PLAN COMMISSION AMENDED AGENDA

August 8, 2024 – 6:00 pm
Village Hall
235 Hickory Street, Pewaukee, WI 53072

TO: Village of Pewaukee Plan Commission
CC: Jenna Peter - Clerk
FROM: Jeff Muenkel AICP, Planning Consultant
RPT DATE: June 28, 2024
MTG DATE: July 11, 2024
RE: Edward Jones – Business Site Plan & Conditional Use Request

Village of Pewaukee Plan Commission
Engineer's Report for August 8, 2024

EDWARD JONES | NORTH (FRONT) ELEVATION

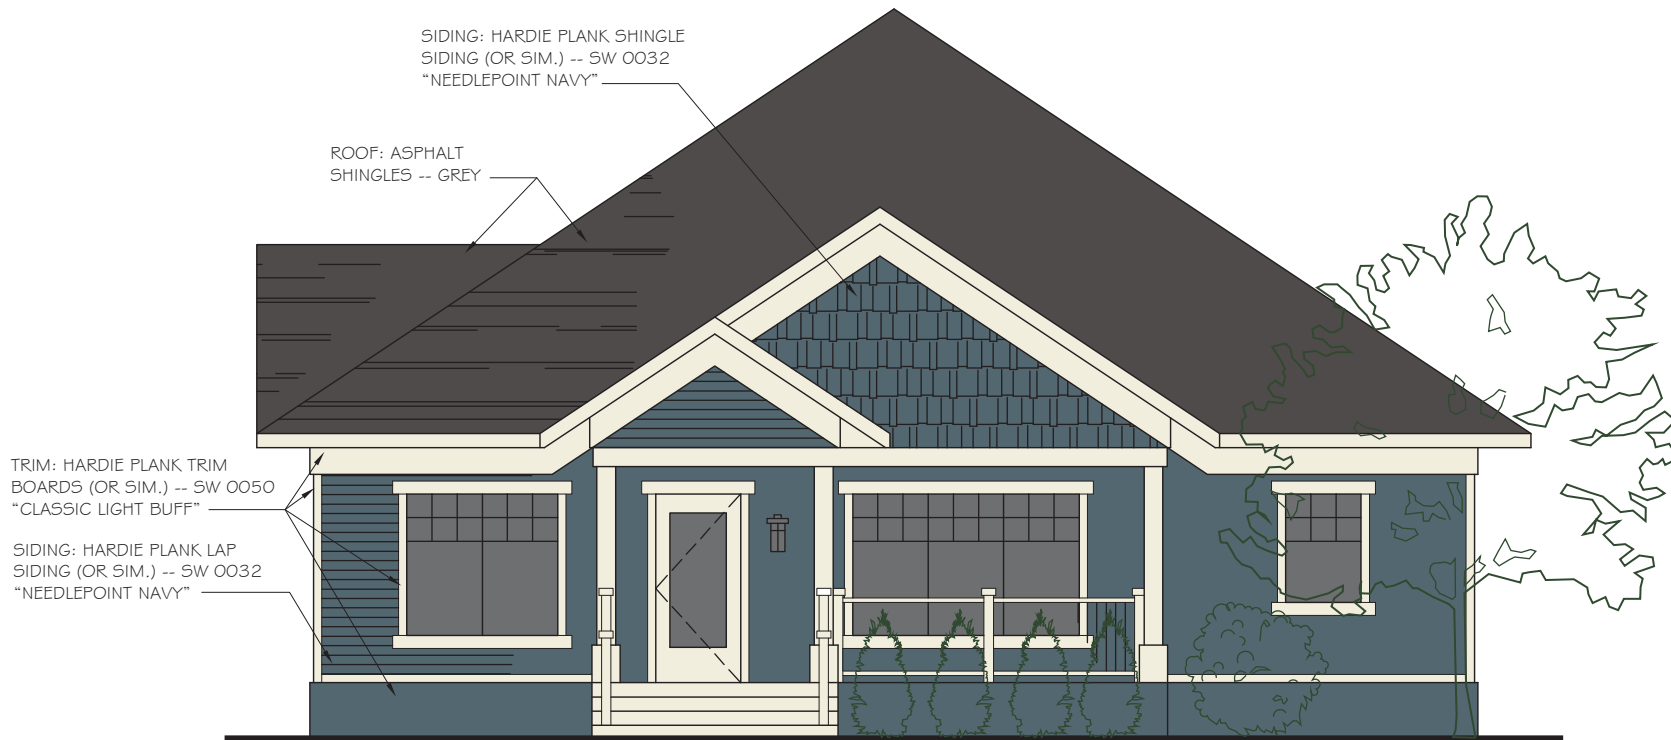
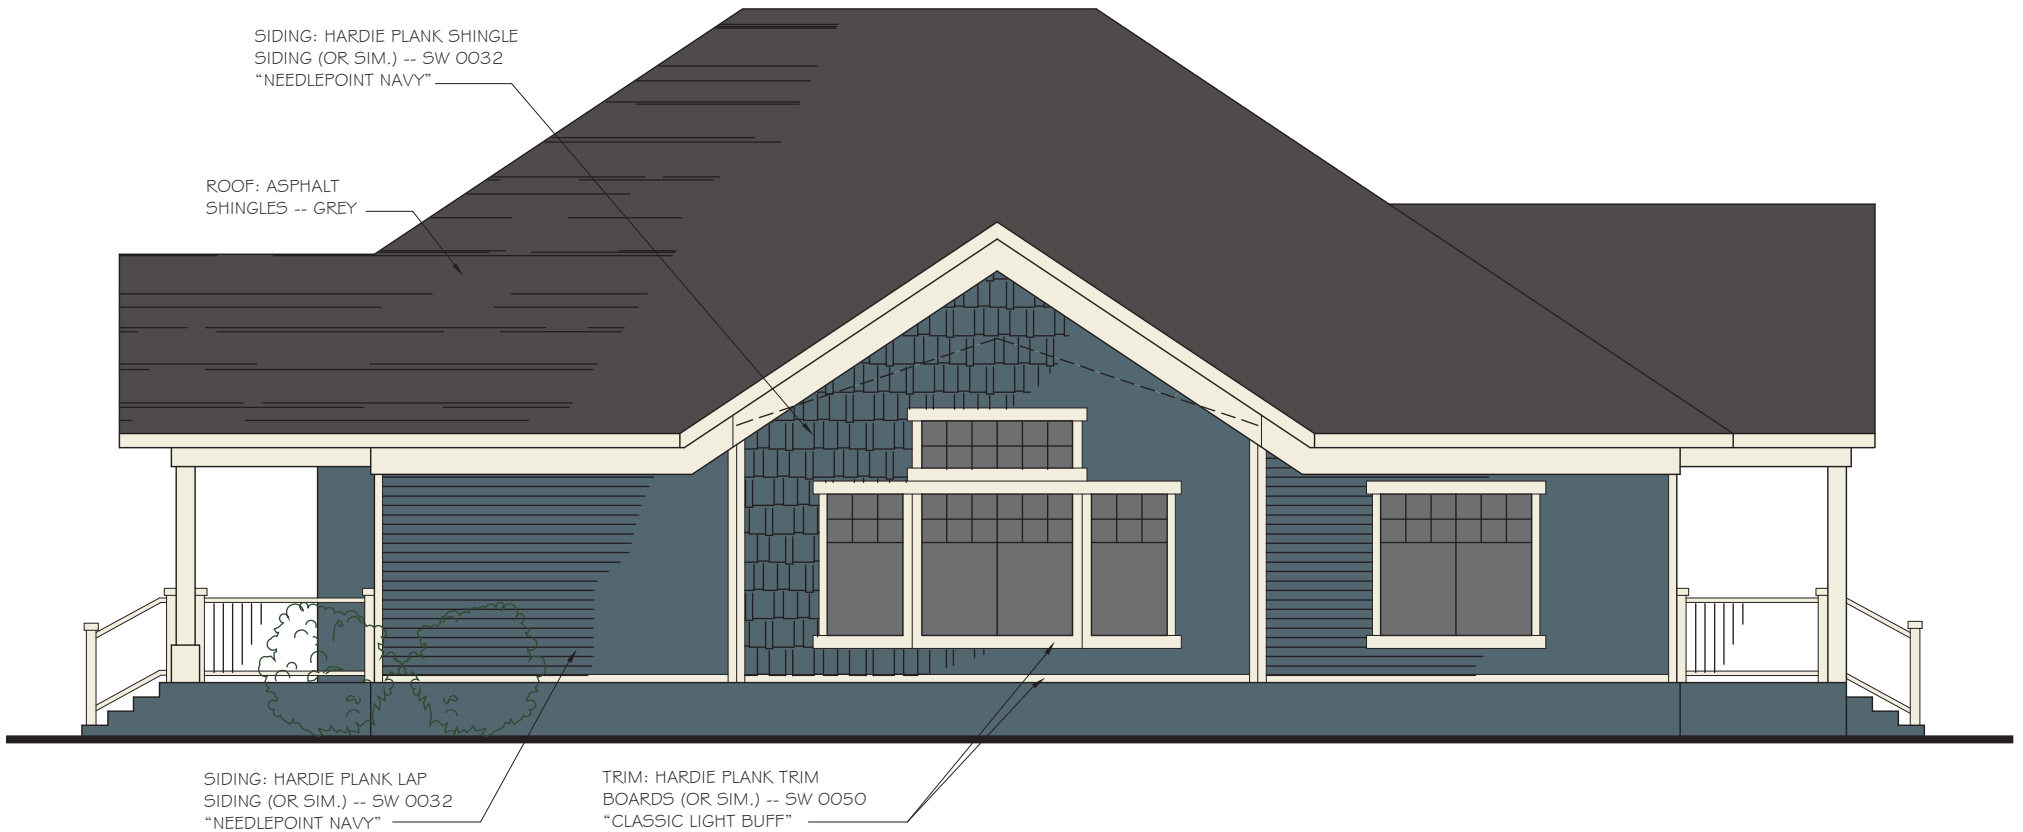
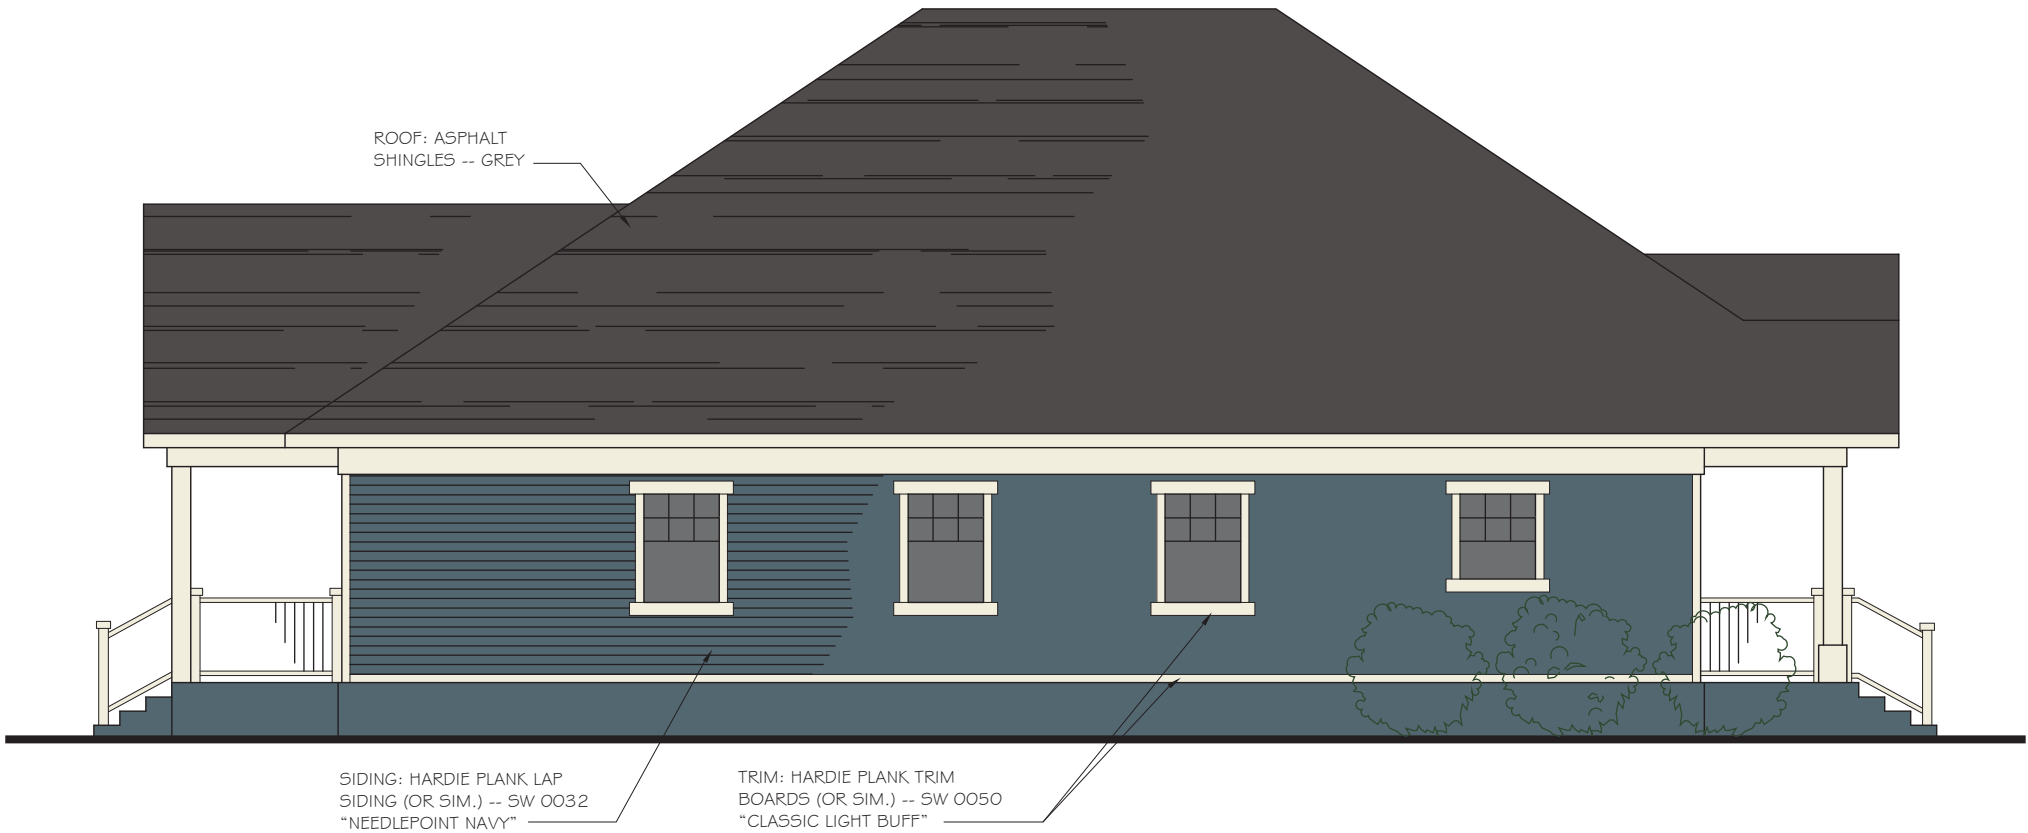
- f. **Architecture.** The building elevations and renderings show a one-story office structure. The structure is proposed with materials consisting of Hardie Plank trim/siding (horizontal and shake) and asphalt shingles. The main color of the siding proposed is "Needlepoint Navy", the trim as "Classic Light Buff" and the shingle as "Grey". The structure contains four-sided architecture throughout, has multiple trimmed windows with muntins, multiple gabled roofline, and multiple decks leading up to the entrances.

For the most part the design requirements appear to have been met. Items for Plan Commission further discussion may include the following:

- 1. No stone or brick is used. The design requirements allow cement board siding (which is the primary material proposed) but the code states that this is usually "in combination with brick or other accepted masonry".
- 2. Roof shingles are not shown as architectural shingles as of now.
- 3. One last note is that it appears that the existing accessory structure is to remain as-is for architecture. The Plan Commission should discuss the architecture intentions with the petitioner and if any of the materials should compliment the principal structure architecture upon completion.

C0.2

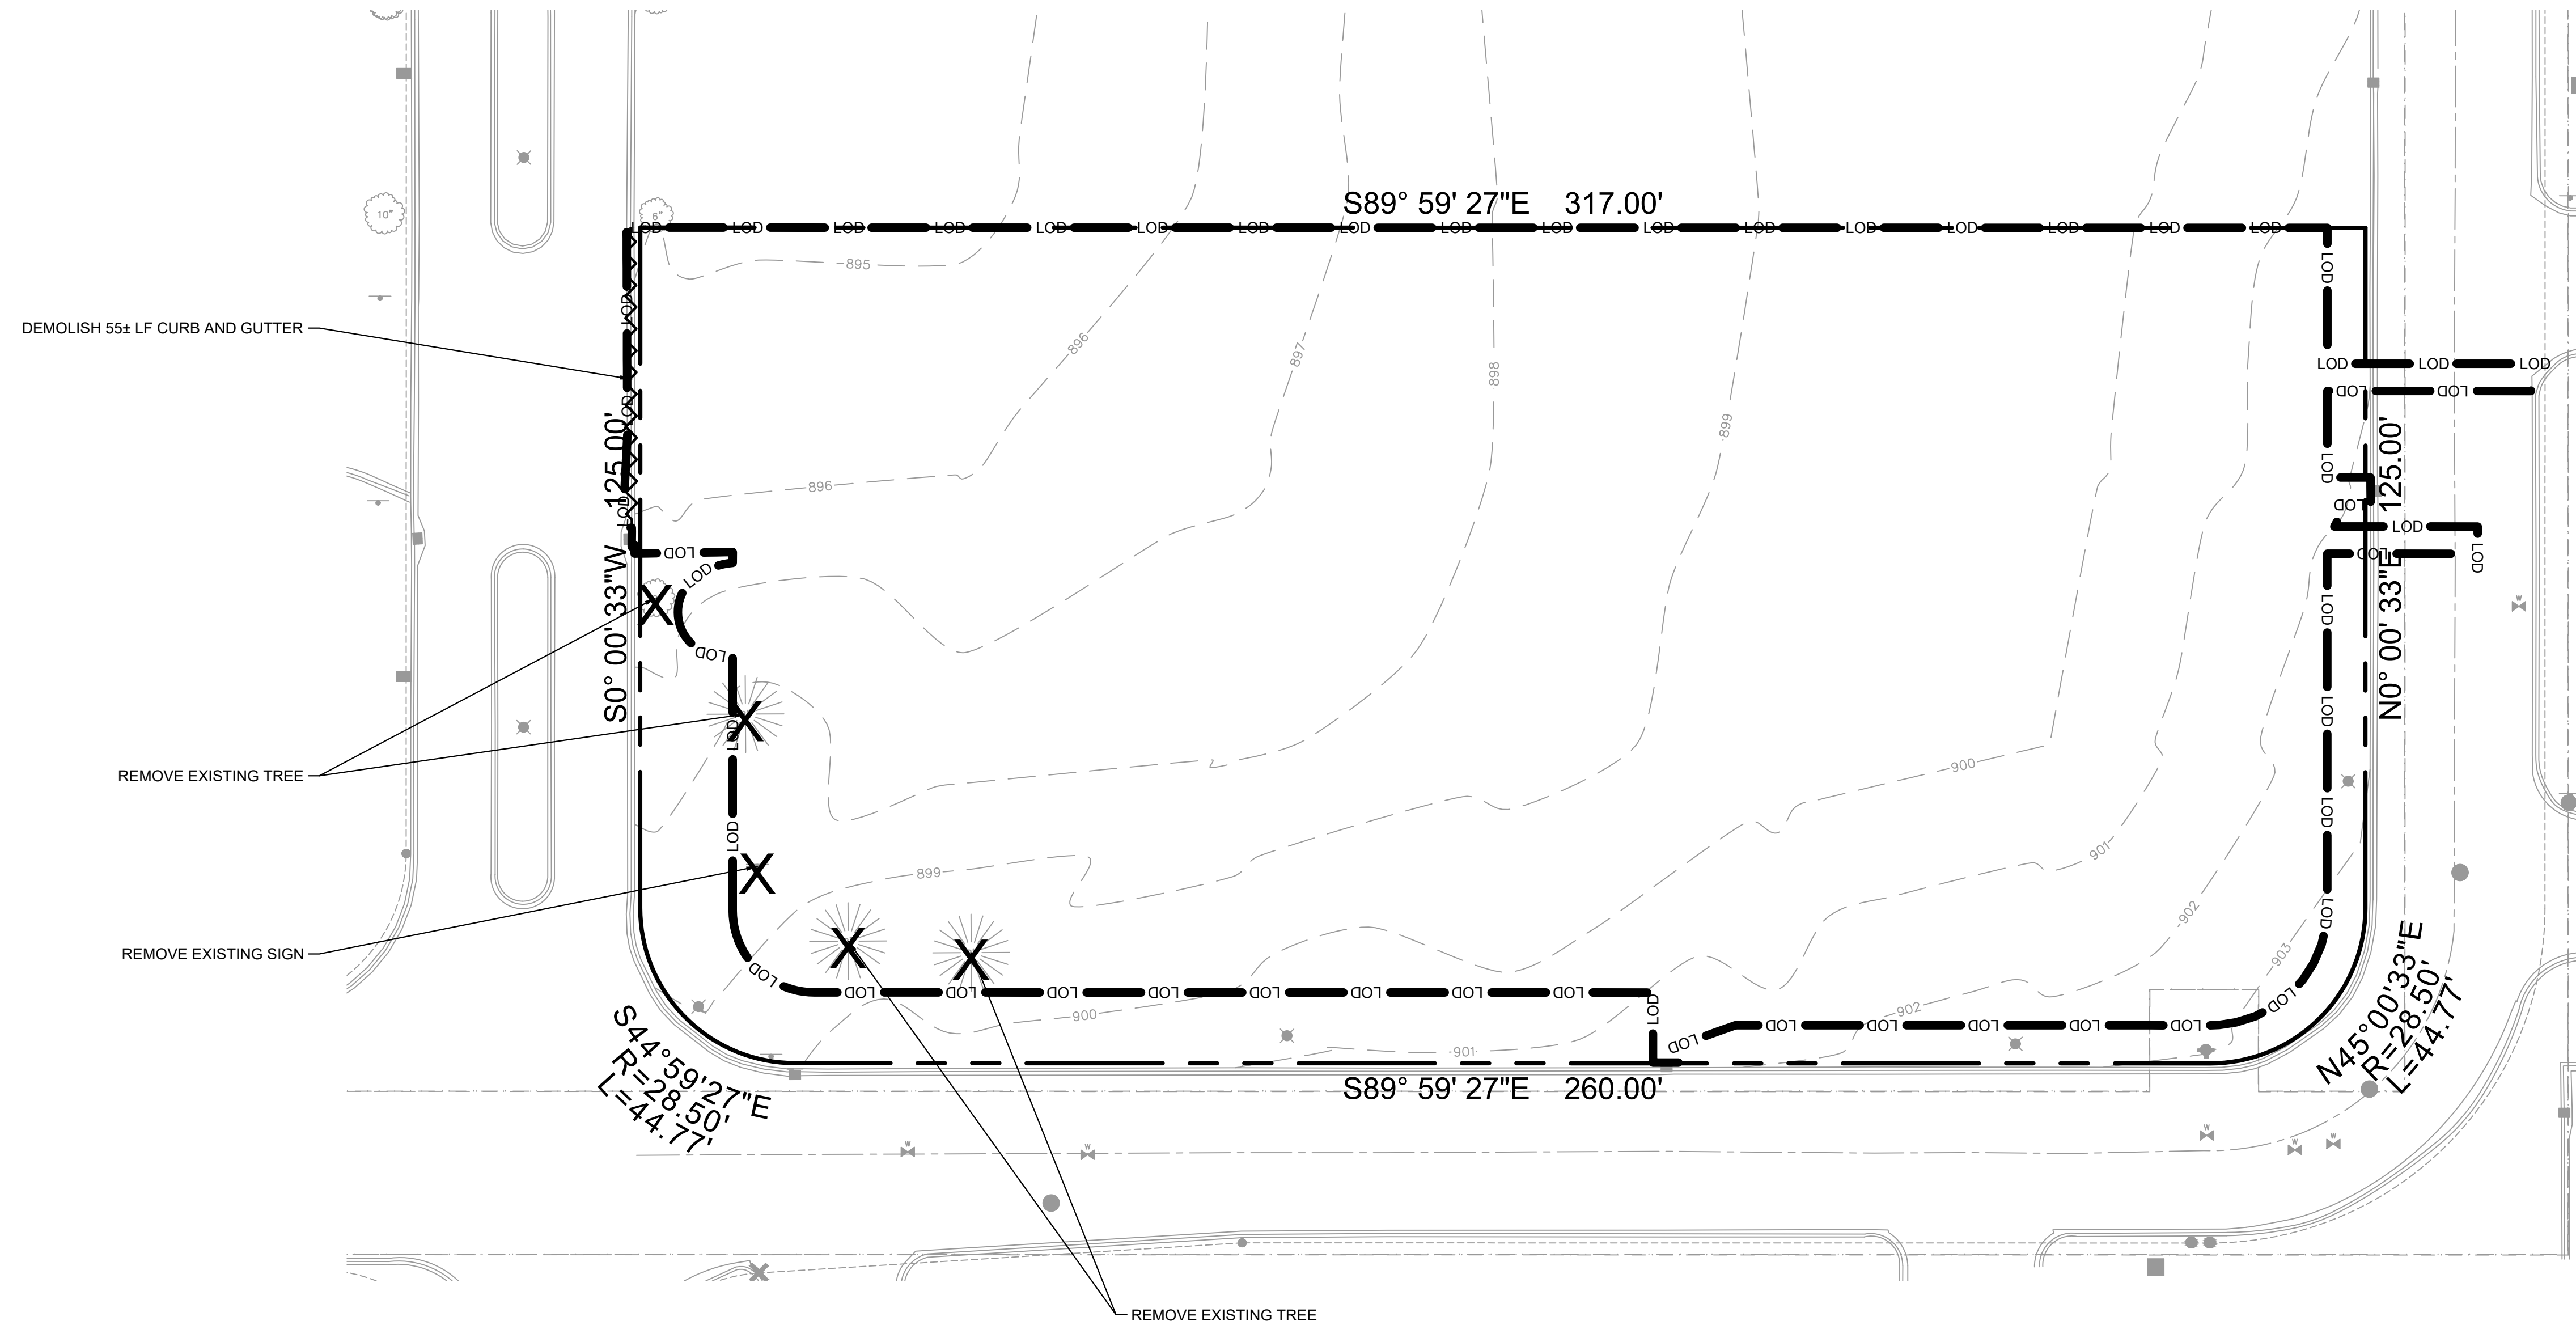
Sheet C0.1
